भारत सरकार – रेल मंत्रालय  
 अनुसंधान अभिकल्प और मानक संगठन  
 लखनऊ – 226011  
 Government of India - Ministry of Railways  
 Research, Designs & Standards Organization,  
 LUCKNOW - 226011

**MODIFICATION SHEET NO. RDSO/2012/EL/MS/0413, Rev. '1' Dated 25.04.2016**

Paralleling of interlocks of EP contactors and auxiliary contactors of three phase locomotives to improve reliability.

MODIFIED SCHEMATIC POSITION : 52/5  
AUXILIARY CONTACTOR

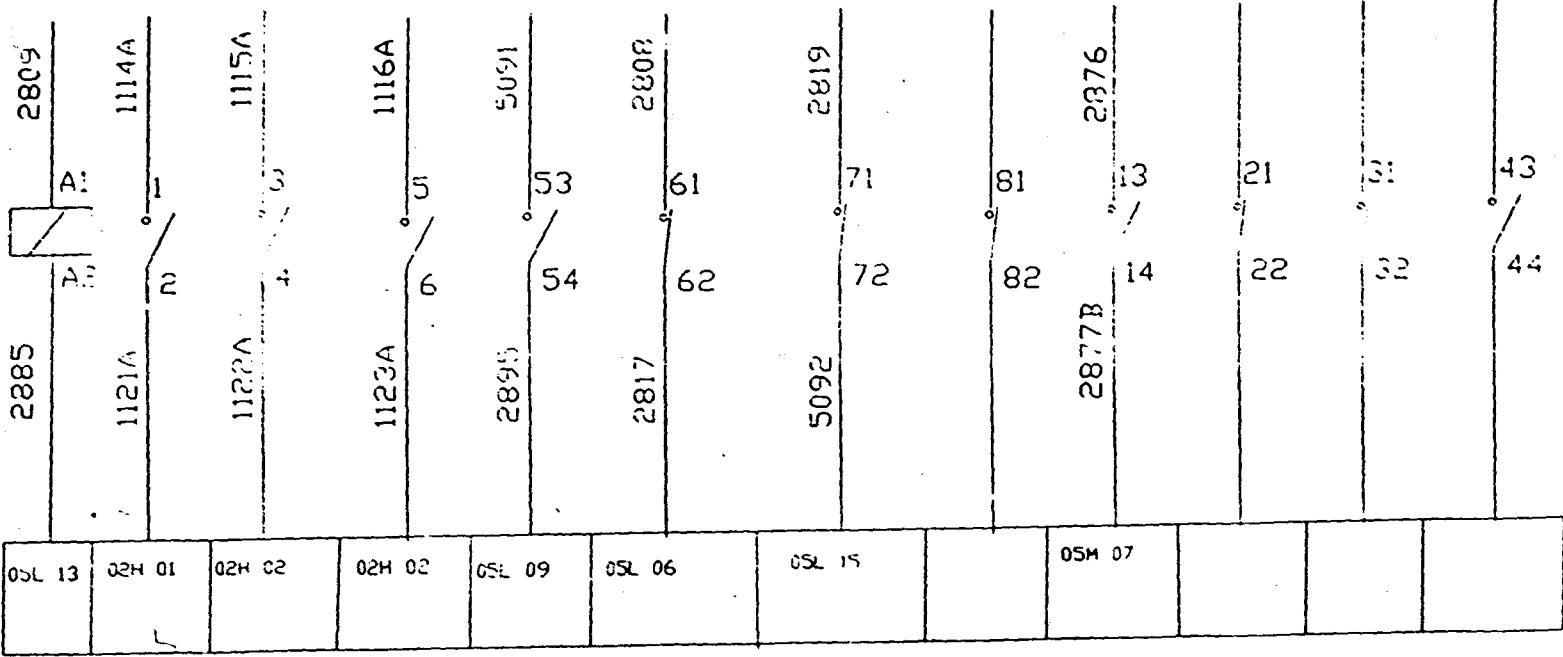
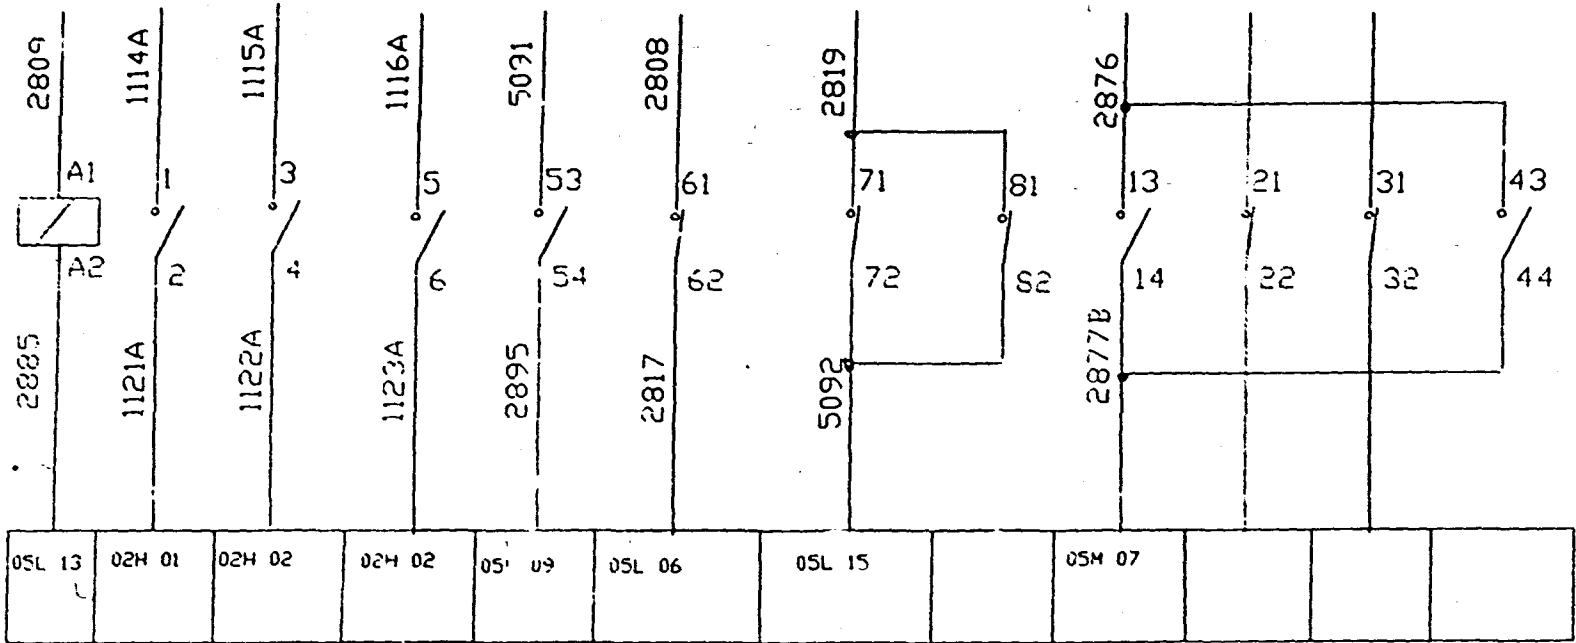
5.	52/4 & 52/5	Auxiliary Contactor	01 NO + 02 NC	01 NO	01 NC	01 NO + 02 NC	HB-1	In type LADN-13 the spare 81-82 NC I/L is to be paralleled with used NC I/L 71-72. In type LADN-22 the spare NO I/L 43-44 is to be

paralleled with used NO I/L 13-14.
6.	52.5/1 & 2*	Contactor oil pump	Replaced by LADN-22 of sch. pos. 126.7/1 & 2	01 NO	....	01 NO + 02 NC	HB-2	In place of LADN-13, LADN-22 is to be used hence the spare NO I/L 43-44 is to be paralleled with used NO I/L 13-14.
7.	126.7/1 & 2*	Contactor power supply cab	01 NO + 01 NC	Replaced by LADN-13 of sch. pos. 52.5/1 & 2	02 NC	....	SB-1 /SB-2	Cable no. 2097 A and 2099A are connected across NO I/L 53-54 and cable no. 2503B and 2504B are connected across NC I/L 61-62 for 126.7/1. Similarly circuit to be modified for 126.7/2.
8.	8.41	Contactor discharging resistor	....	02 NO + 01 NC	....	01 NC	FB	The spare NC interlock 7-8 is to be paralleled with used NC interlock 5-6, connect cable no. 2863A & 2863B. For the modified circuit diagram refer to Rev. '1' modified schematic position: 8.41 of Annexure-2

MODIFIED SCHEMATIC POSITION : 52.5/1  
Contactor Oil Pump-1

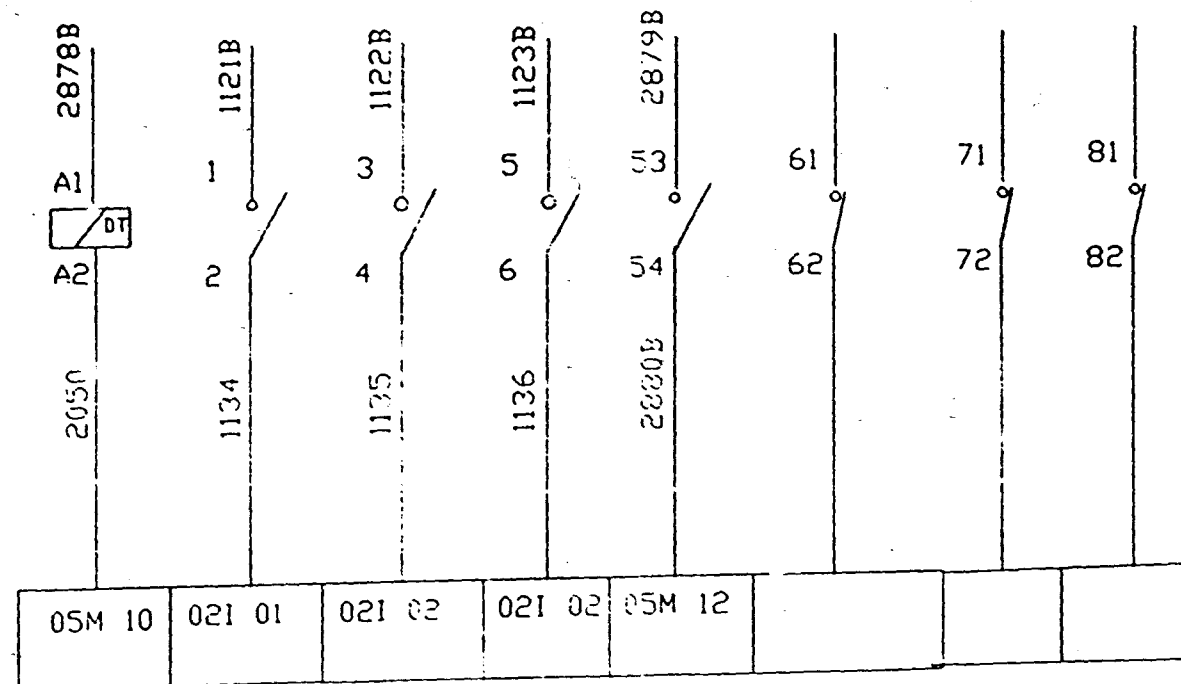
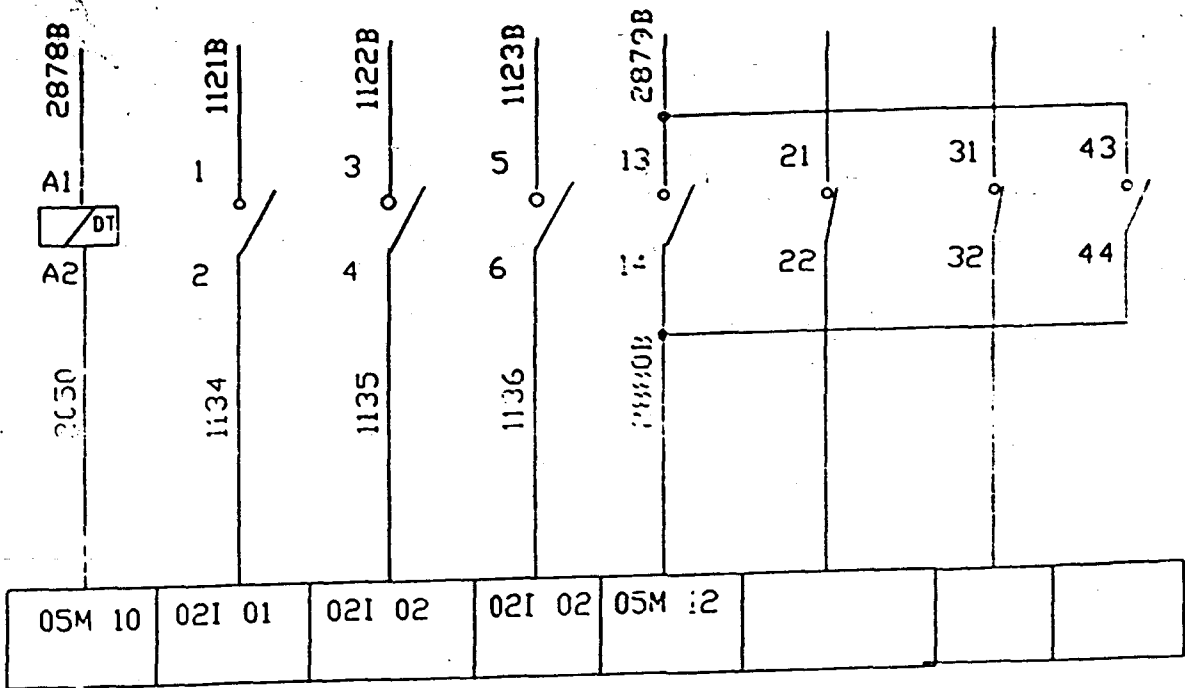
**\* to facilitate SN 6 and 7 above, the LADN-13 of contactor 52.5/1&2 to be interchanged with LADN-22 of 126.7/1&2.**
